**RE: Preliminary Design Investigation (PDI) Work Plan – Addendum
Marinette Former Manufactured Gas Plant Site, Marinette, Wisconsin
Wisconsin Public Service Corporation
CERCLA Docket No. V-W-06-C-847; Site Spill ID – B5BT; CERCLIS ID – WIN000509952**

This letter serves as Addendum 1 to the Preliminary Design Investigation Work Plan (PDI Work Plan) – Revision 2, dated March 13, 2020, for the WPSC Marinette Former Manufactured Gas Plant (MGP) (the Site).

MARINETTE MARINE PROPOSED DELINEATION BORINGS

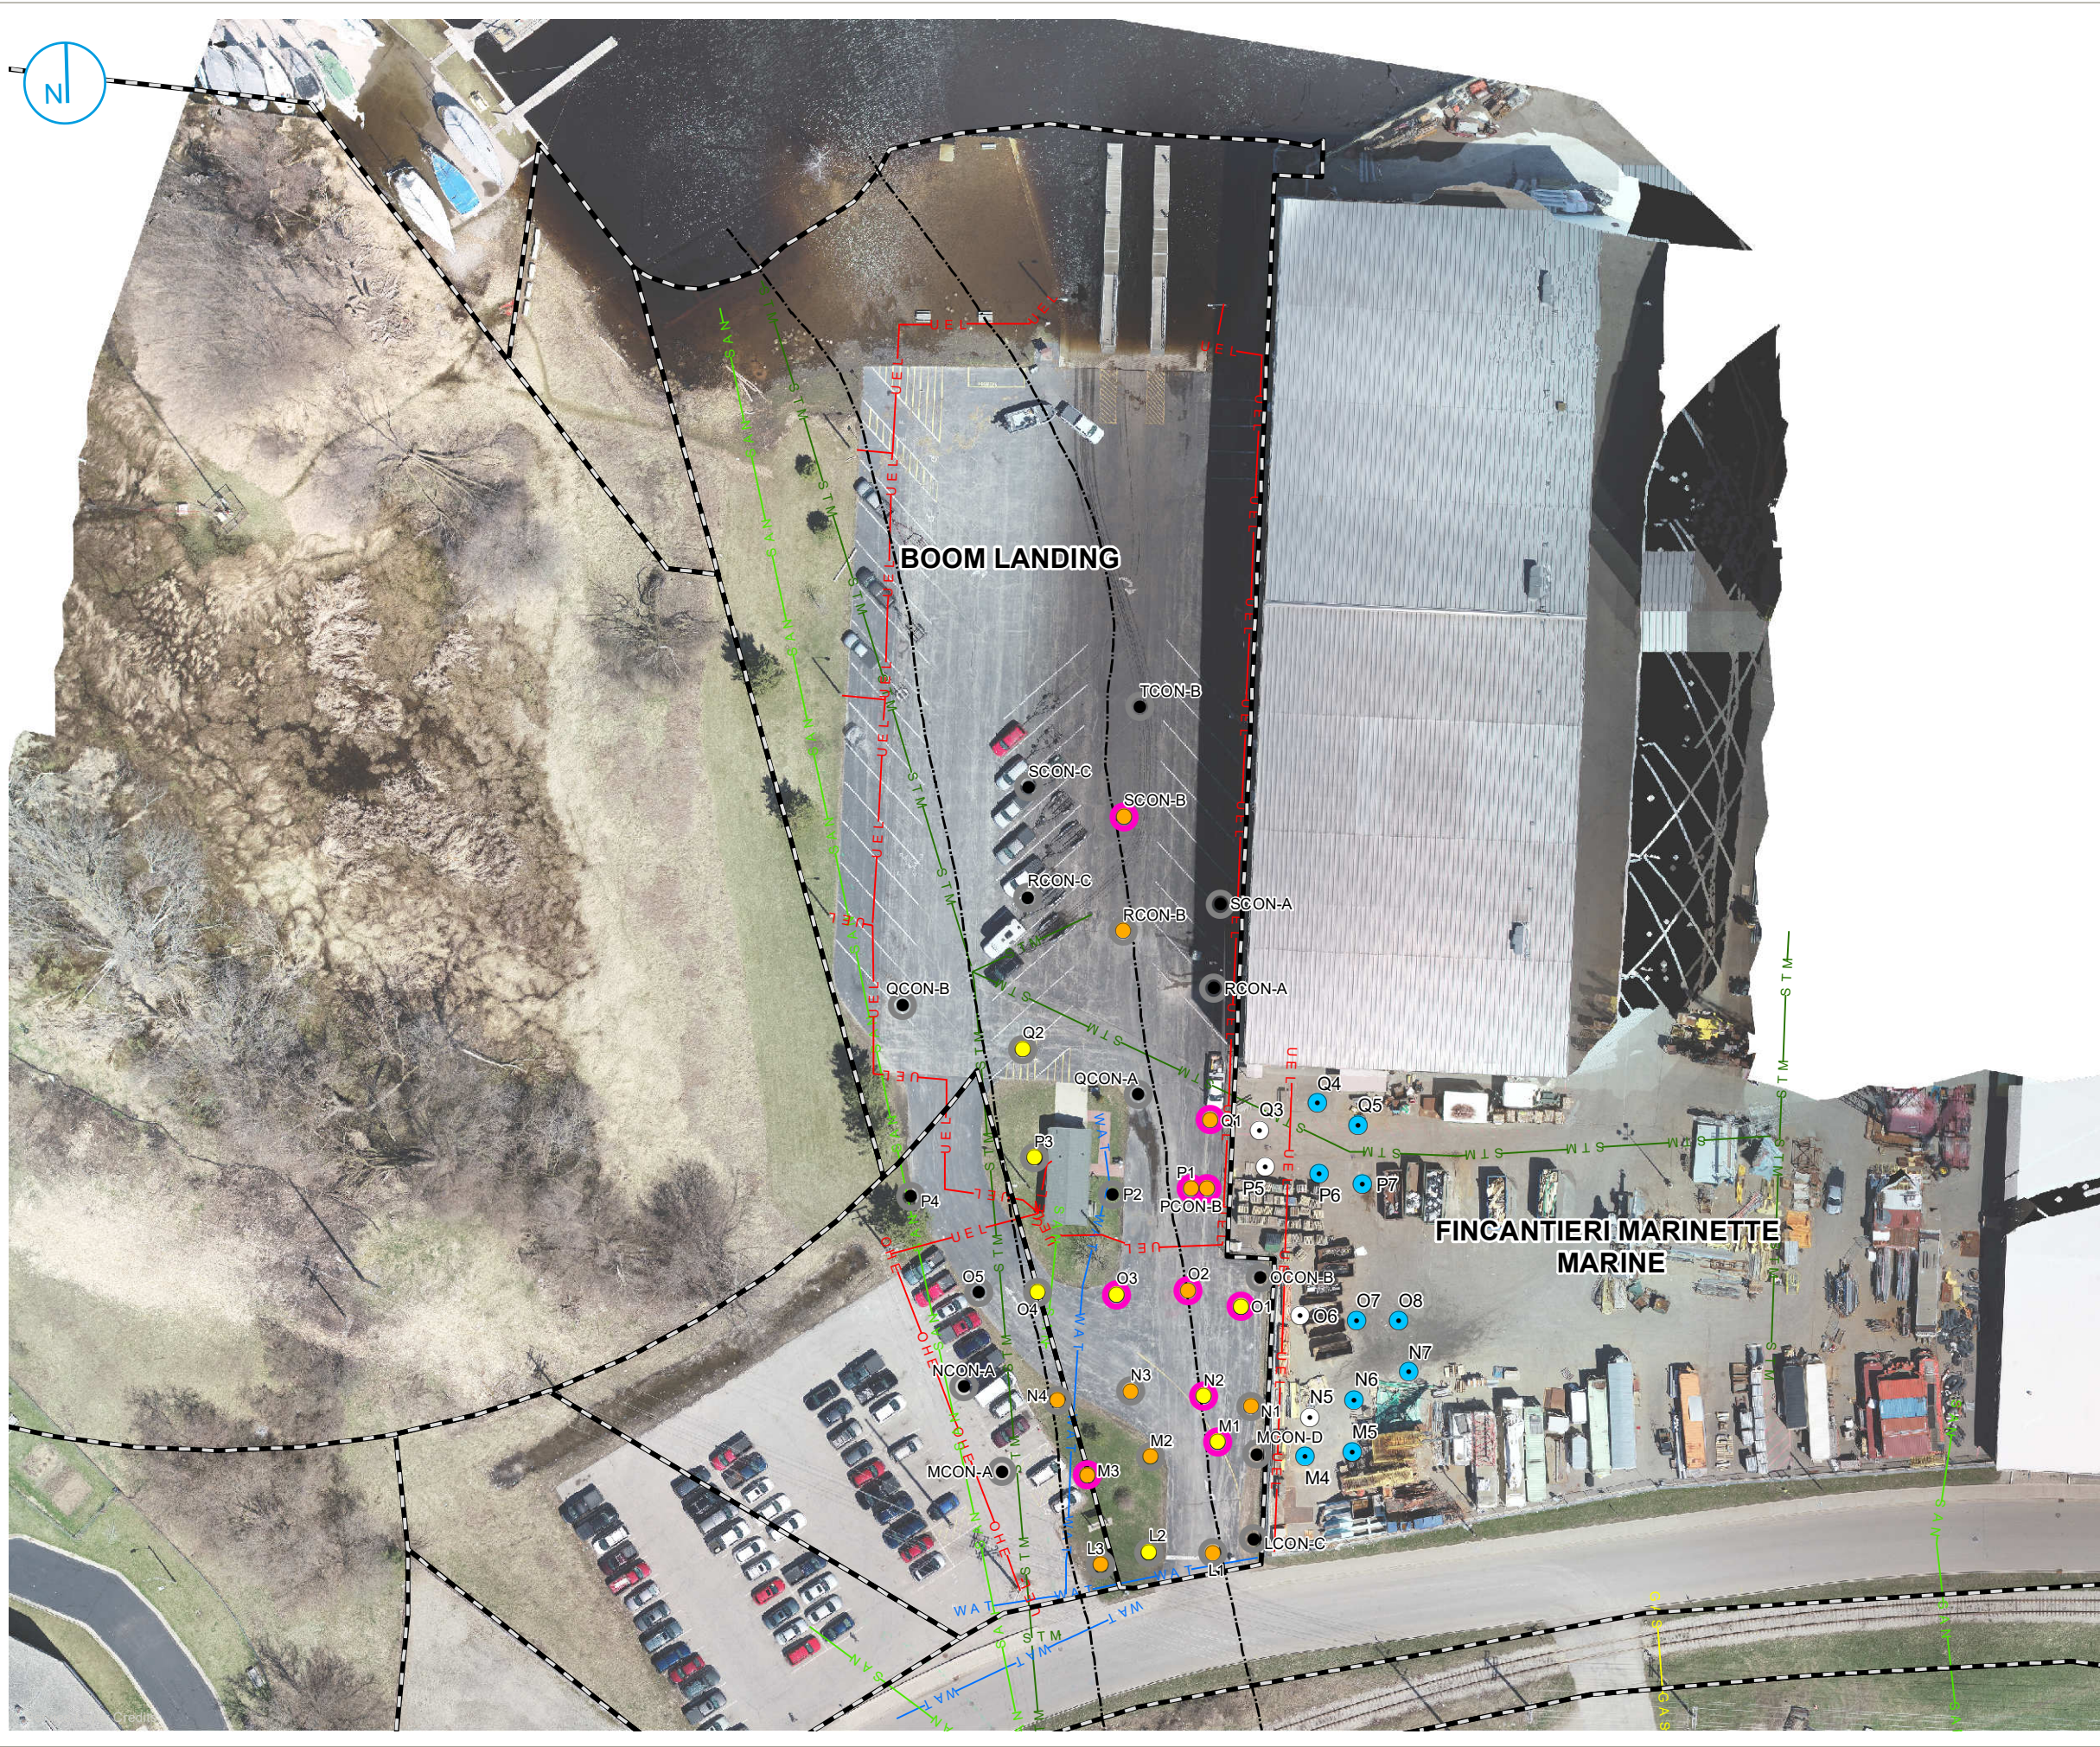
Four additional soil borings are proposed to complete delineation of source material in the equipment storage yard at FMM. The proposed locations of these soil borings are shown on Figure 1 and sampling rationale is outlined in Table 1. Soil borings will be completed and sampled consistent with Section 4.3.1 of the PDI Work Plan, Revision 2. Additional contingent step-out borings will be advanced in the event that a definition of extent of source material impacts in this area is not achieved after the installation of the initial delineation borings. The potential locations of contingent delineation step-out borings are also shown on Figure 1; however, these locations may be modified to reflect actual delineation data gaps and possible above- or below-ground physical obstructions present on the FMM property. The precise number and locations of the delineation borings will also be confirmed in the course of WPSC negotiating and executing an access agreement with FMM.

As noted, the work will be conducted in accordance with the procedures outlined in the PDI Work Plan, Revision 2. Prior to advancing the soil borings, a public and private utility locate will be performed. Sonic borings will be advanced at the locations shown on Figure 1. Once the borings are completed, a topographic, boundary, and utility survey will be conducted on this portion of the FMM property including: property boundaries, structures and driveway entrances, easements, above-ground and underground utilities as identified during the utility locate process, existing site features such as fences, fence gates, asphalt/concrete surfaces, the final location of the soil borings, and a site topographic survey with 1-foot contours.
